Approved for access by the
Solid Waste Department for a compactor trash enclosure
1 recycle trash enclosure. **Phase 2 SDP-2**
Herman Gallegos 05-24-22

NEW OFFICE/WAREHOUSE
FOR BRUNACINI DEVELOPMENT
541 AIRPORT DRIVE, NW
ALBUQUERQUE, NEW MEXICO

DRAWING NAME
SITE DEVELOPMENT
PLAN
PHASE ONE

DATE MAY 2022
NORTH SCALE
1"=50'-0"
OR AS NOTED
DRAWING NAME
SITE DEVELOPMENT
PLAN
PHASE TWO
SHEET NUMBER

1 SITE PLAN- PHASE TWO
1"=50'

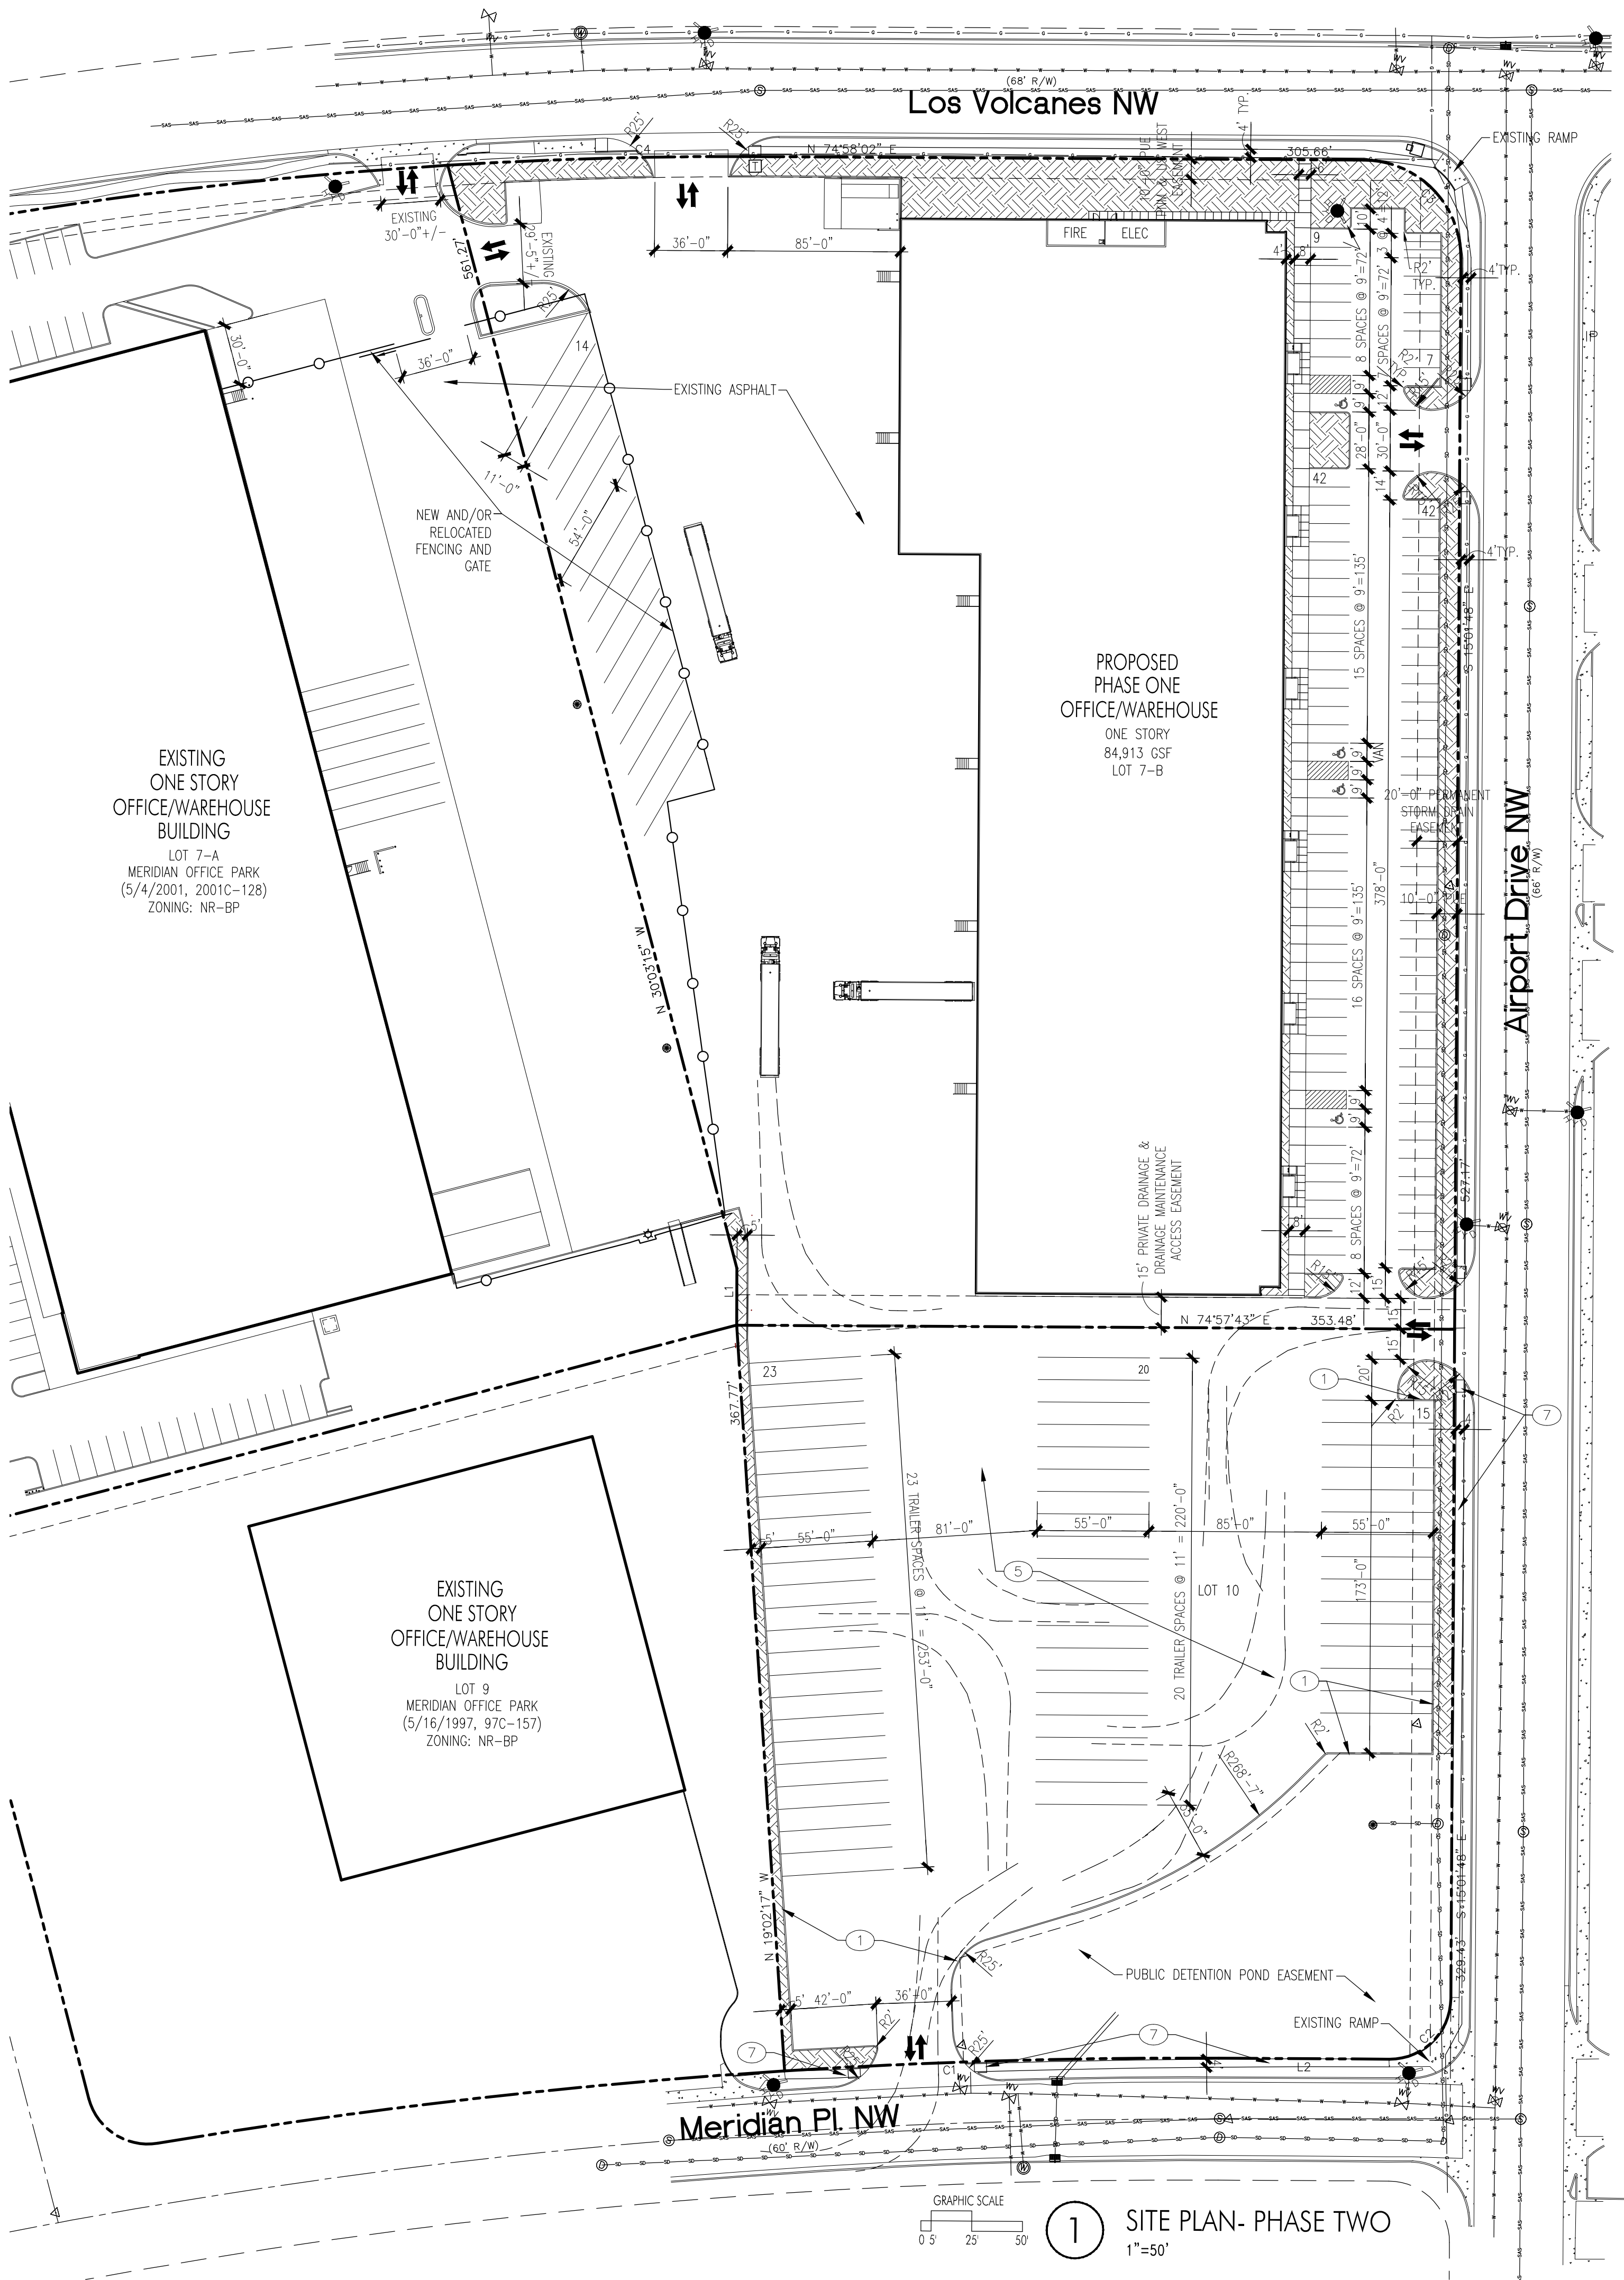
Approved for access by the
Solid Waste Department for a compactor trash enclosure
1 recycle trash enclosure.
Herman Gallegos 05-24-22/Herman Gallegos
